Re: Rapiscan AIT System Radiation Survey Reporting

Secure 1000 Radiation Emission Measurement	FORM R-0646-1 (Single Pose)
---	---	--------------------------------

R-0646-1 Addendum (Documentation Errors)

Product Name	Secure 1000SP (Single Pose)
Serial Number	S51018003
Radiation Emission Measurement	Radiation Survey Dated: 09/15/2010
RSO Initials

1. In Beam Dose Measurement: Survey Table. 1

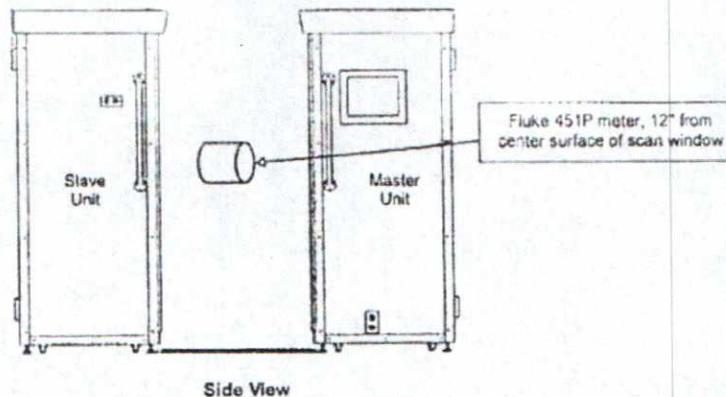
No value indicated for background radiation. Typical values range from 7uRem/hr to 13uRem/hr at sea level. Note: Absence of value has no adverse impact on calculations.

The service technician should attend refresher training.

The corrected data indicates this system was operating within expected parameters. No re-survey is required for this system.
